WAGERUP REFINERY UNIT THREE

ENVIRONMENTAL REVIEW AND MANAGEMENT PROGRAM

Response to Public Submissions

ALCOA WORLD ALUMINA AUSTRALIA

Figure 1: Average (99.5th percentile) acetaldehyde 3 minute concentrations ($\mu\text{g}/\text{m}^3$) (data assimilated) for the existing (top) and expanded refinery (bottom)

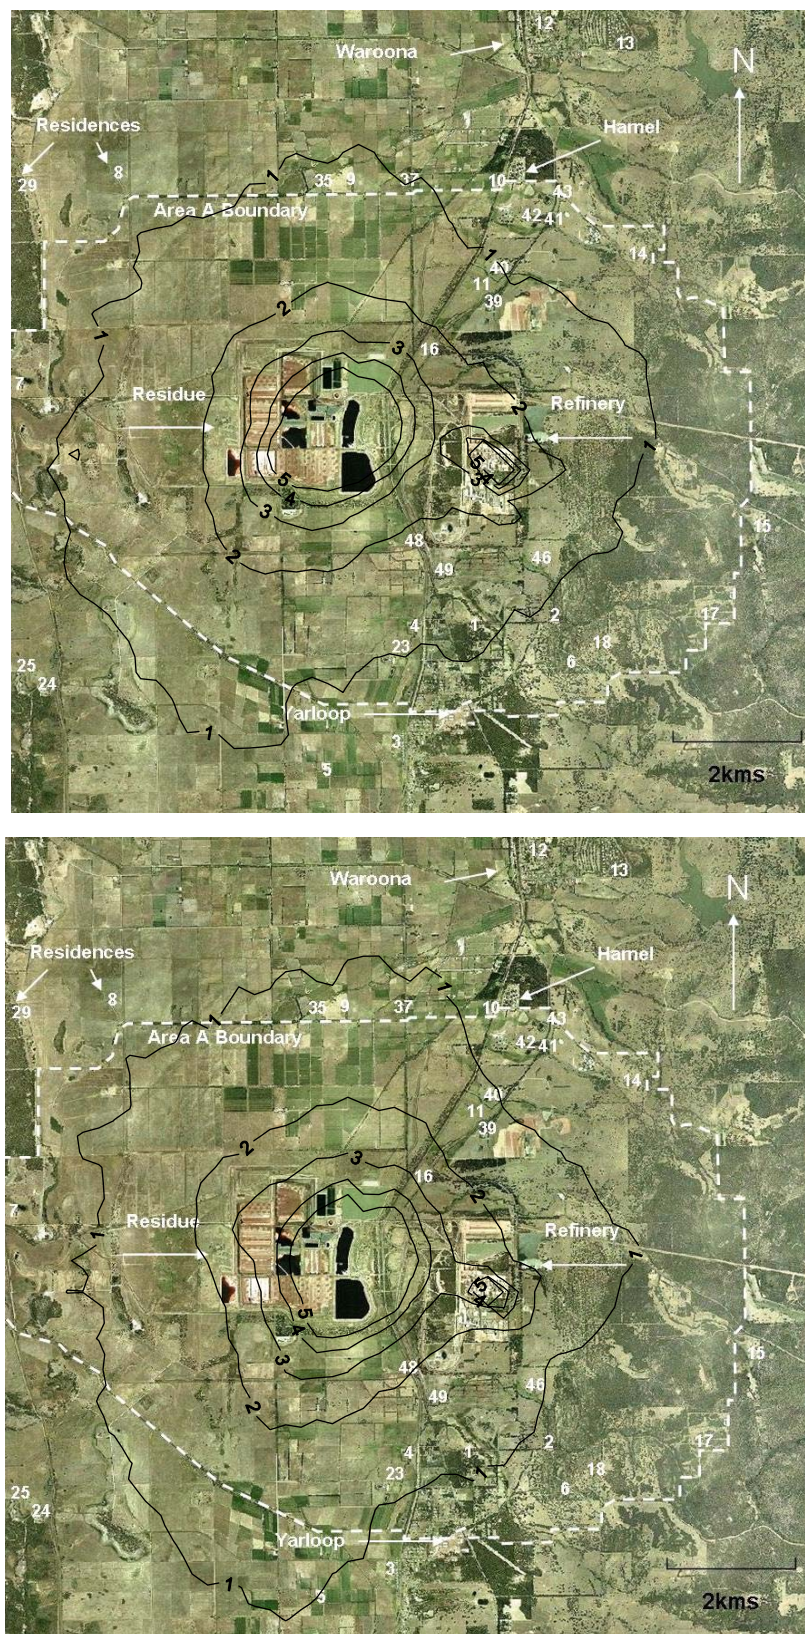
The AQD has questioned that if the initial estimation of 25A odour emissions is over-predicted, and the existing and expanded refinery odour emissions are substantially below those predicted in the ERMP, then the margin of reduction achieved by odour control actions on 25A may also be over-predicted. The potential consequences of this could include that the predicted lower odour impacts from reducing 25A odour emissions may not be sufficient to offset the increased odour impacts due to higher calciner emissions.

The acetaldehyde contours predicted for the 99.9th percentile 3 minute peak emissions and 99.5th percentile 3 minute average emissions cases are presented in Figures 1 and 2 and show no material differences between the existing refinery and the cogeneration expansion case.

Figure 5: Calciner 3 OPSIS Measured Formaldehyde emissions July to October 2003

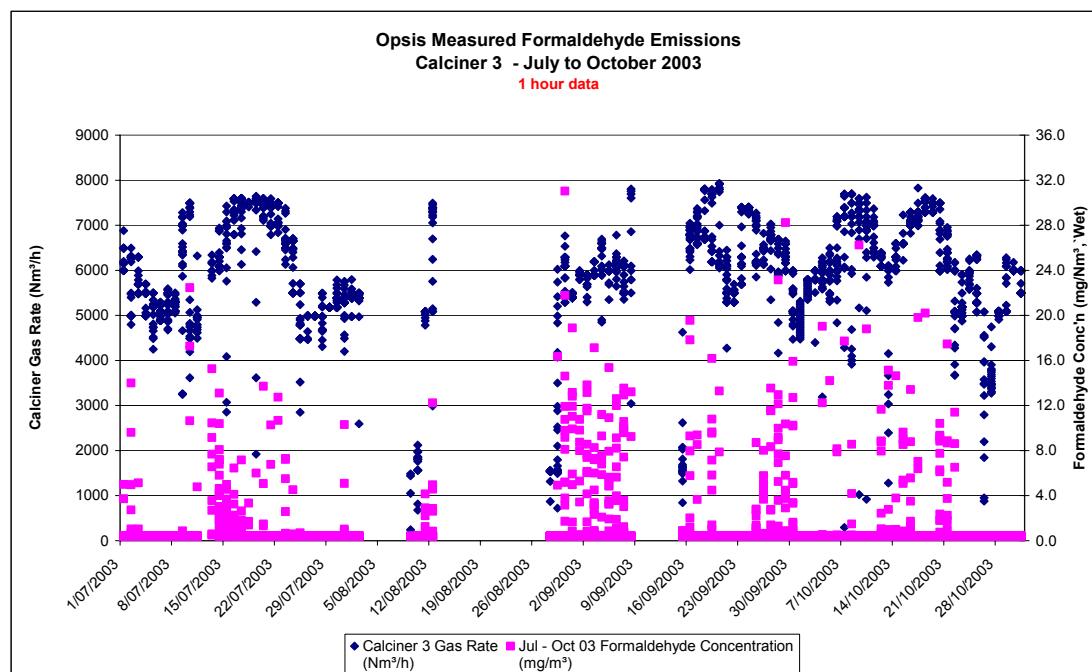
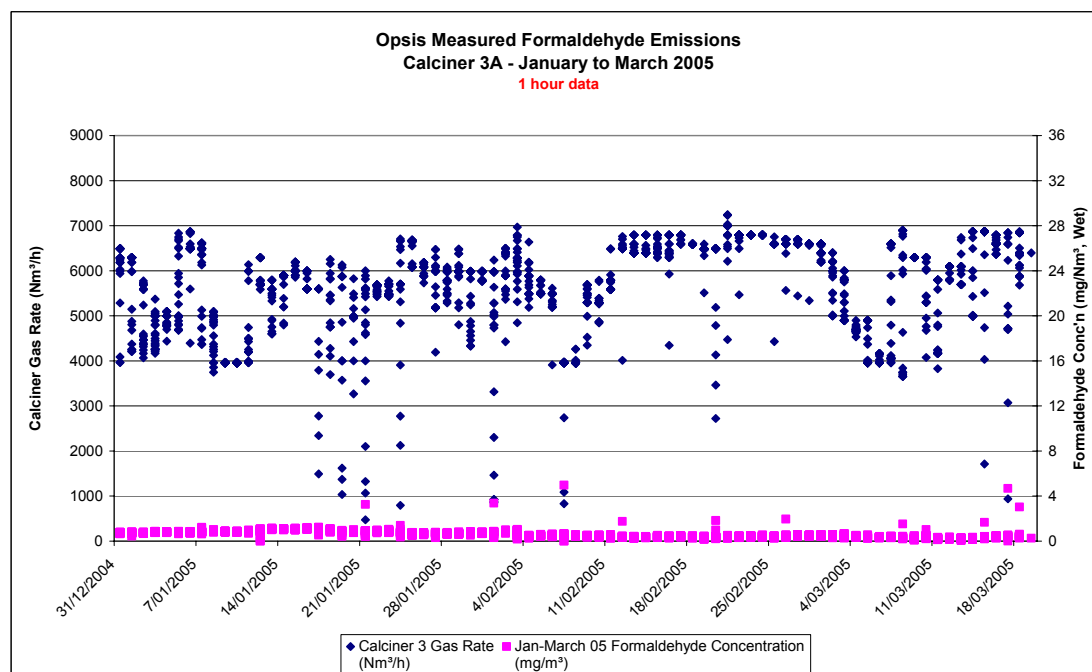
It is not correct to say that Calciner 3 emission control measures have not been effective. A report has been submitted to the DoE on the Calciner 3 results of the improvements. This report contains a detailed statistical analysis of Calciner 3 formaldehyde emissions and compares the pre-upgrade concentrations to those following the upgrade. A copy of the report is provided in Appendix K

Figure 5 below shows the formaldehyde levels prior to the upgrade. The pink series represents the formaldehyde concentration and it is evident that there was significant instability and surges in formaldehyde levels as a result of the “surging” issue.

Figure 6 below shows the formaldehyde levels monitored during the period January – March 2005. This figure clearly illustrates that the instability that was present prior to the upgrade has been rectified, with formaldehyde emissions substantially reduced.

Figure 7: Modelled extent of 35dB(A) noise contour under worst-case propagation conditions (simultaneously in all directions) relative to the Area A boundary. Expanded refinery case (current refinery also shows contour is within the Area boundary)

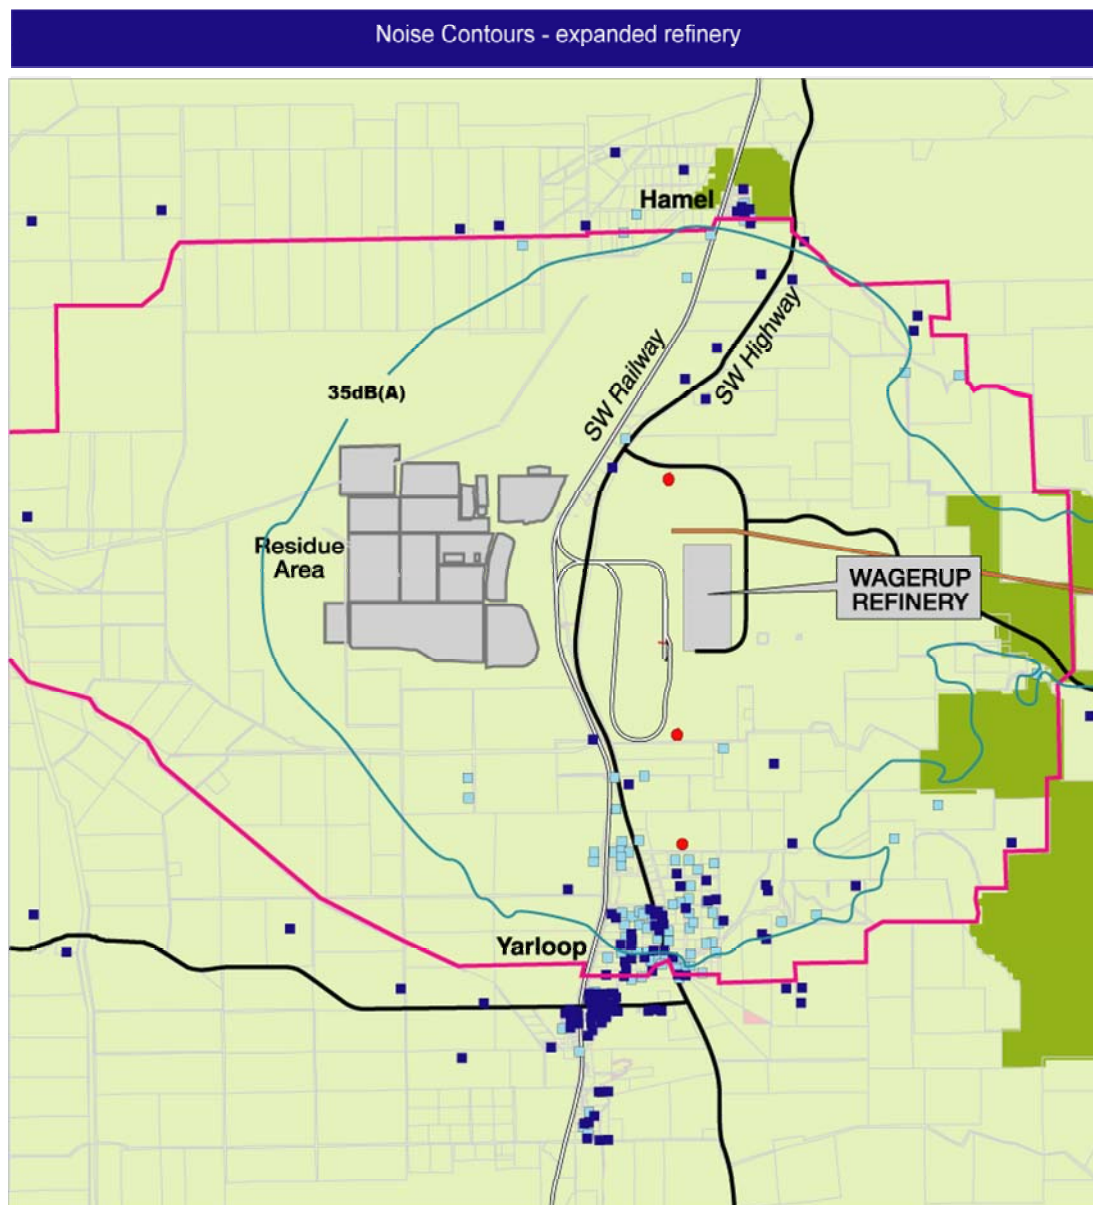
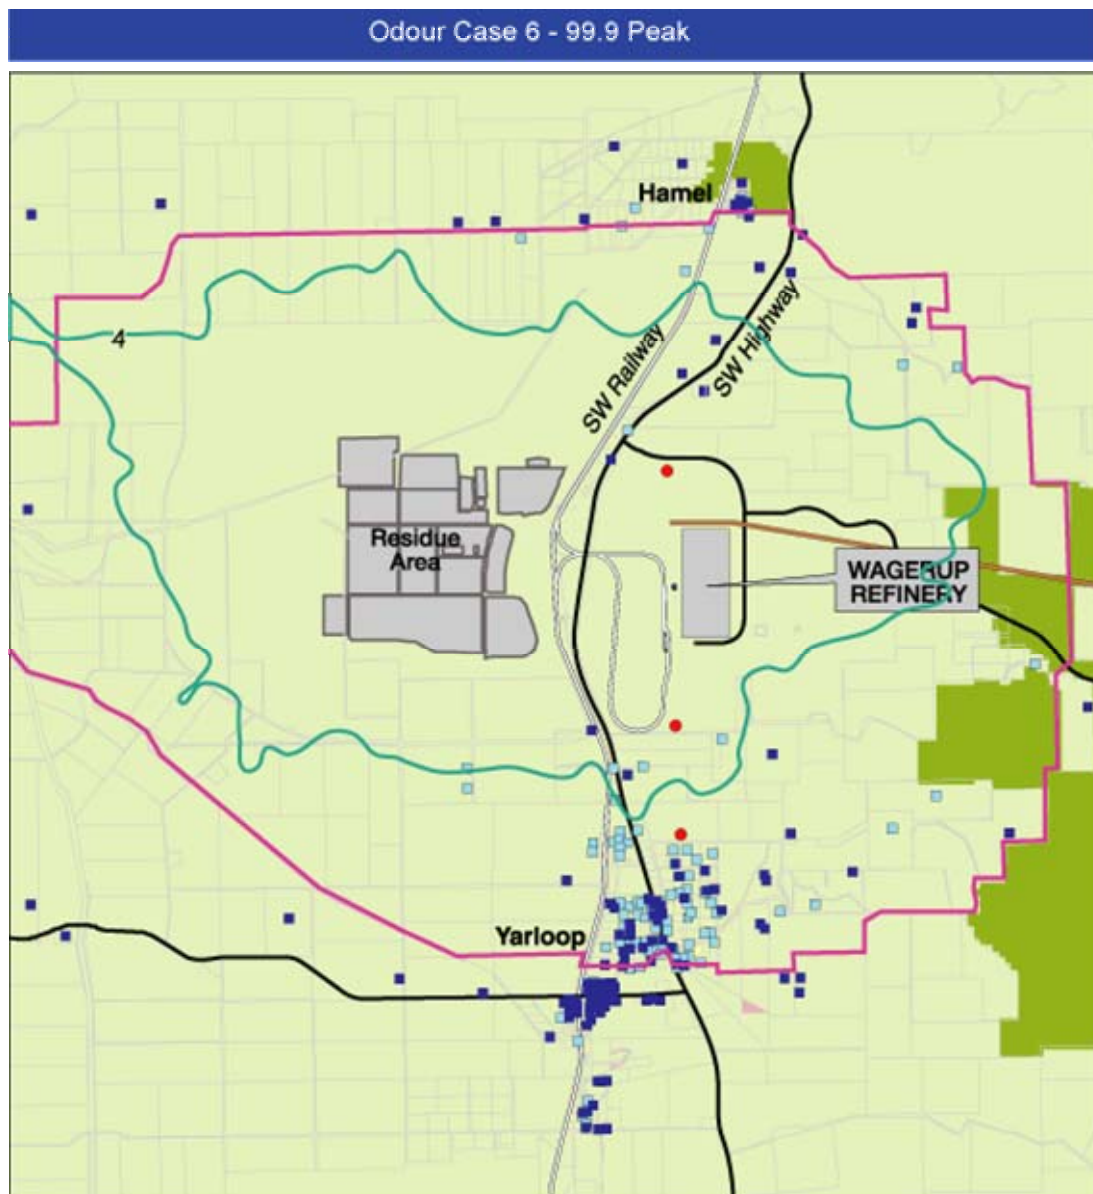
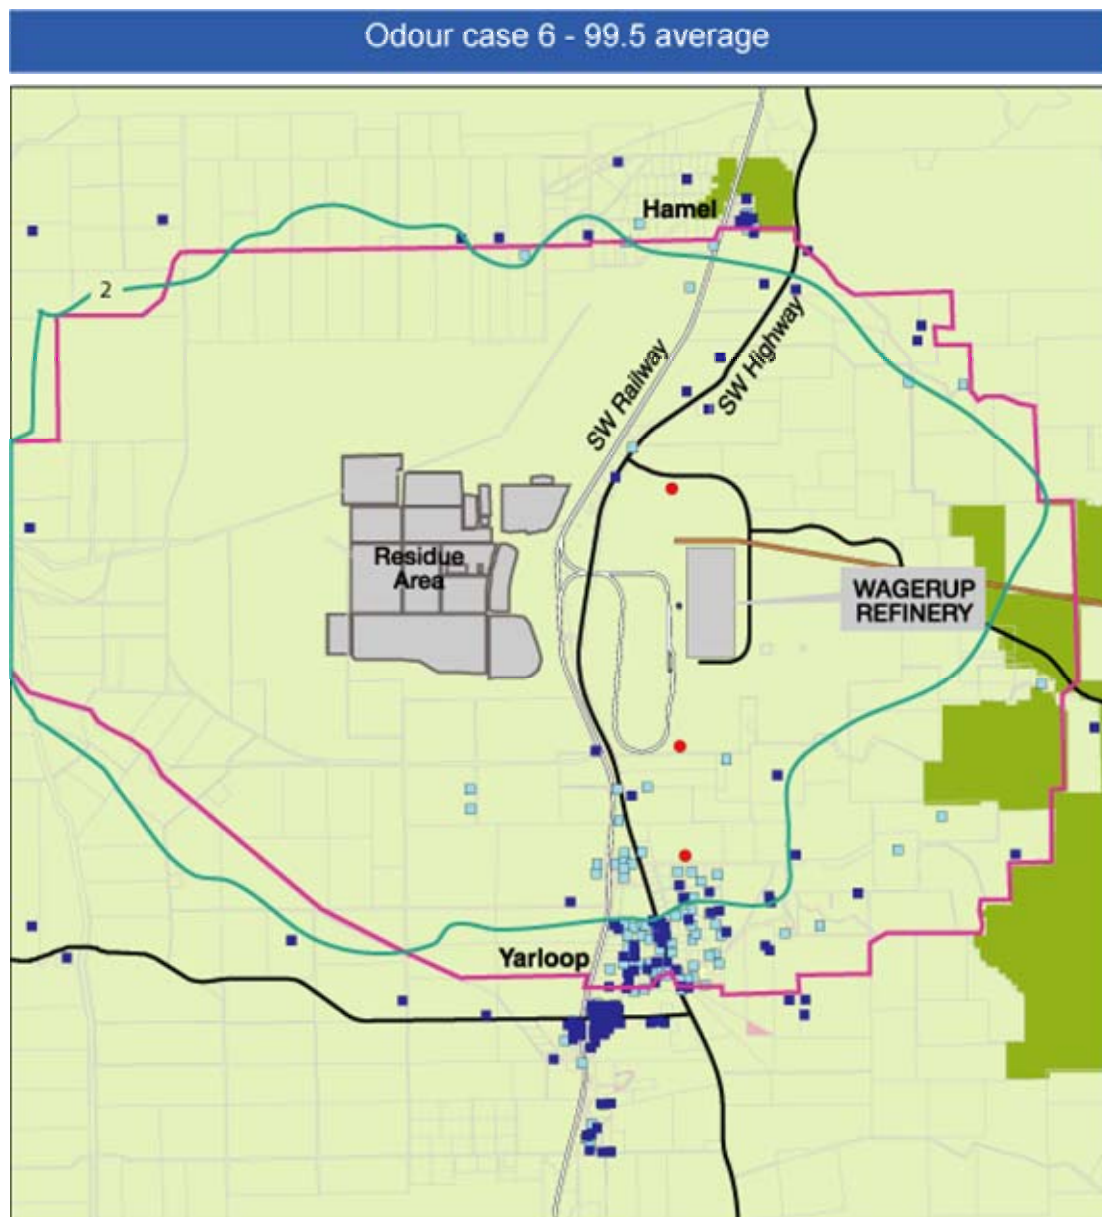
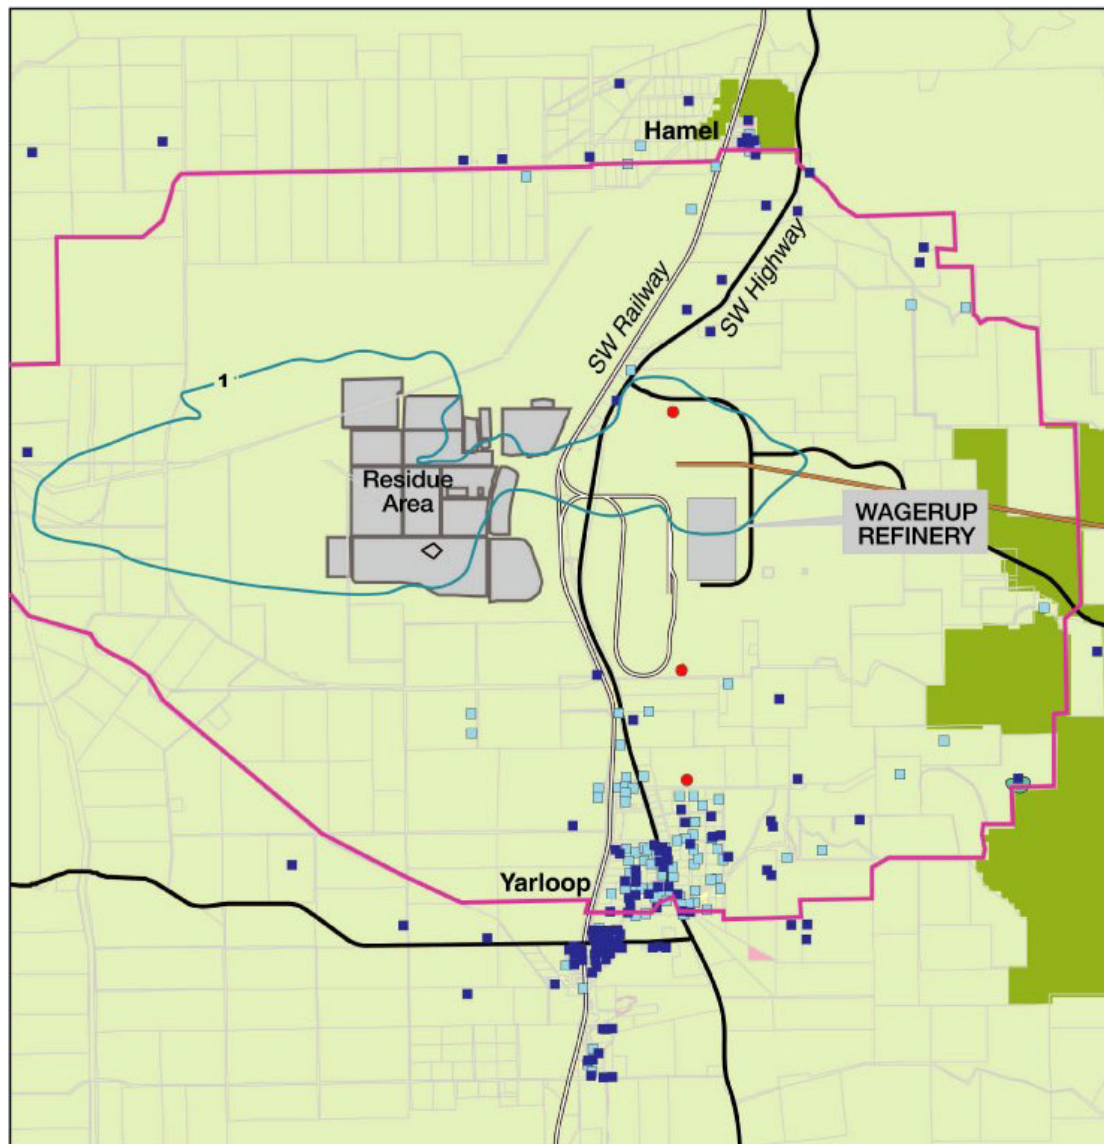
Alcoa agrees with the DoH point that a land planning control area should not just be based on noise contours. Alcoa believes the scientific investigations undertaken for the ERMP now allow for consideration of a relevant planning control area to also consider ambient air quality; odour; ground level concentrations of air emissions (chemical compounds and dust); and a quantitative health risk assessment (HRA). Consistent with the land-use planning policy, the combination of these environmental factors should be used to determine the extent of any land planning control area.

The results of these investigations show that from all scientific results, for the current refinery and expanded refinery, Area A would represent an appropriate land planning control area. The 35dB(A) noise contour, under worst-case propagation conditions (in any direction) extends to the northern and southern limits of the Area A zone. This was expected as noise was a key factor in identifying the Area A boundary (Figure 7). Examination of key predicted odour contours (99.9 percent, 4 ODU and 99.5 percent, 2 ODU) shows that they are predicted to occur is effectively contained within the Area A boundary (see Figure 8 and 9). However, it is acknowledged that odours will still be noticeable from time to time to some people outside Area A. The HRA results indicate the risk within Area A for short-term, Chronic and cancer risk is low to very low. (e.g. Figure 10).

Figure 11: Relative distance from refinery premises of households most frequently lodging health complaints during 2004 and 2005.

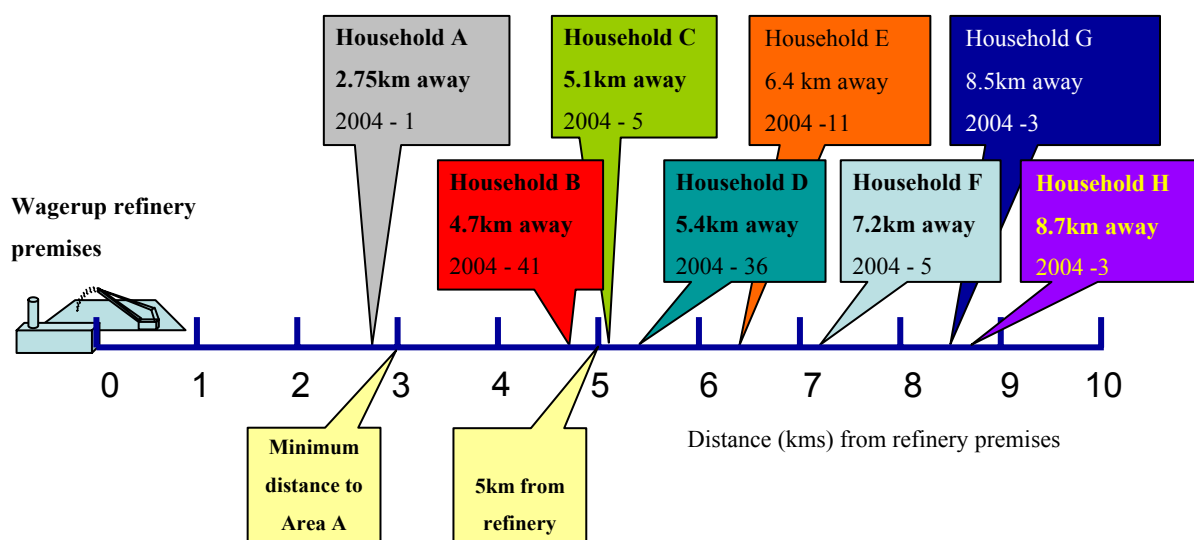
During 2004 Alcoa received a total of 116 health complaints from 19 households. Seven households made more than one complaint and these seven accounted for 90 percent of the total health complaints. The nearest of these seven households is 4.7km from the refinery. The other six are all between 5km and 8km from the refinery, clearly indicating a buffer of 5kms would hold little relevance to the 2004 reports of health impacts.

The distribution of health complaints does not support a buffer zone of 5kms. To accommodate the current households lodging health complaints, a zone of almost twice this distance would be required,
